**ADDENDUM NO. 3 TO PROJECT NO. Q1604**

**HVAC AND ELECTRICAL WORK  
 PROVIDE TEMPORARY BOILER CONNECTIONS  
 FOR TRAILER MOUNTED EMERGENCY HOT WATER BOILER  
 DOWNSTATE CORRECTIONAL FACILITY  
 121 RED SCHOOLHOUSE ROAD  
 FISHKILL, NY 12524**

April 14, 2014

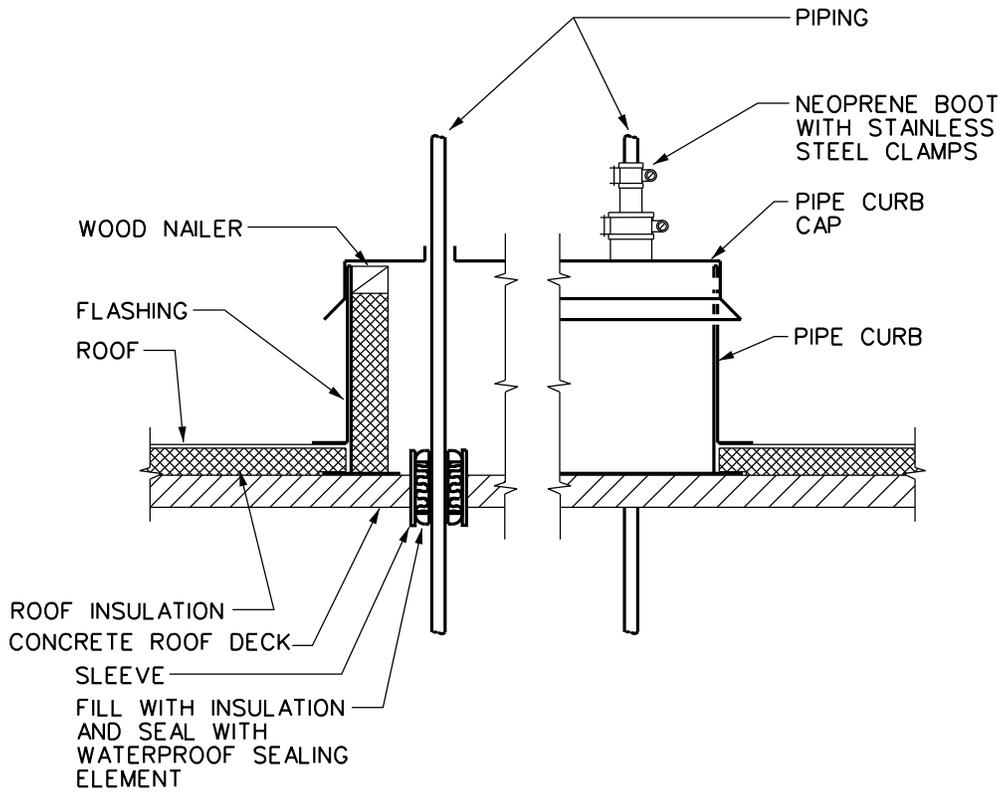
5. Drawing No. M-500:
  - a. Detail 3/M-500, Revise Note 4 to read "Provide roller hanger in accordance with detail 4/M-500."
  - b. Detail 3/M-500, Add to Note 7, "Secure base to roof at first and last support of piping run on roof. Provide epoxy anchor bolt, 1/2" bolt, nut/washer, silicon seal for anchoring.
  - c. Detail 3/M-500, Add Detail Note C, "Existing Building 6 roof warranty has expired."
  - d. Add Detail 5/M-500 Pipe Curb Detail. Refer to attached Sketch ADD-03-SK-M01.

- A. CUT BACK INSULATION AND PROVIDE FLASHING.
- B. LOCATE, SET AND SECURE CURB.
- C. PROVIDE SHIMS WHERE REQUIRED TO LEVEL SUPPORT.
- D. CONFIRM EXISTING ROOF CONSTRUCTION IN FIELD. DETAIL SHOWS ROOF CONSTRUCTION BASED ON FIELD DISCUSSIONS ONLY.
